LOS LUNAS SCHOOLS & VALENCIA COUNTY  
RFP 2022-004-HR  
ASPHALT IMPROVEMENTS AND REPAIRS  
AMENDMENT NO. 2  
DATE: FEBRUARY 2, 2022

**ASPHALT IMPROVEMENTS AND REPAIRS  
FOR  
LOS LUNAS SCHOOL DISTRICT AND VALENCIA COUNTY  
RFP NO. 2022-004-HR  
RFP Amendment No. 2  
February 2, 2022**

The above referenced RFP #2022-004-HR has been amended as follows:

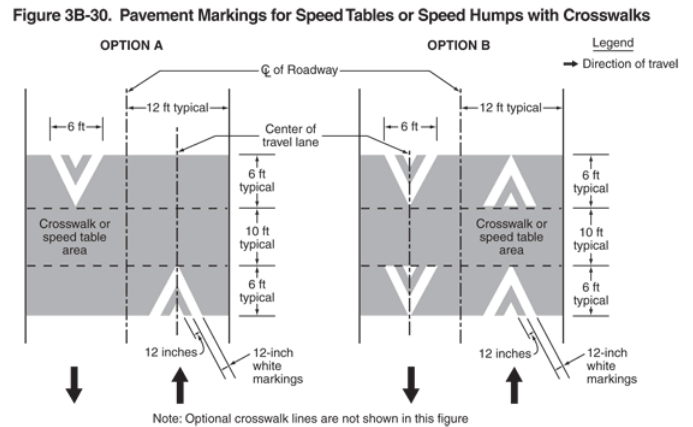
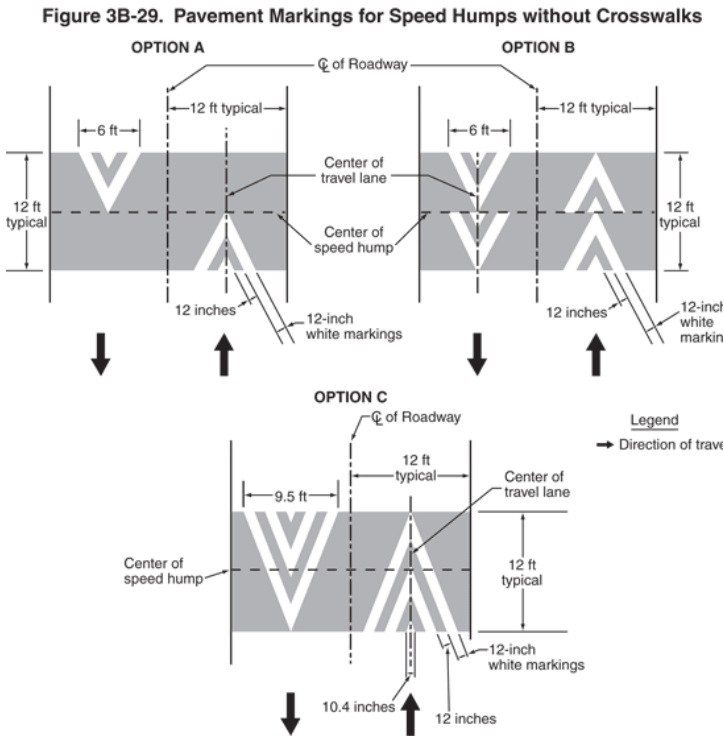
h) For item 83 “Striping of Speed Humps”, which MUTCD option is to be used for shark’s teeth, there are two.

There are actually 5 different options depending if there is a cross walk or not. Here are the options below. You rarely see a crosswalk on a speed hump. Option A of “Pavement Markings for Speed Humps without a crosswalk” would be the standard.
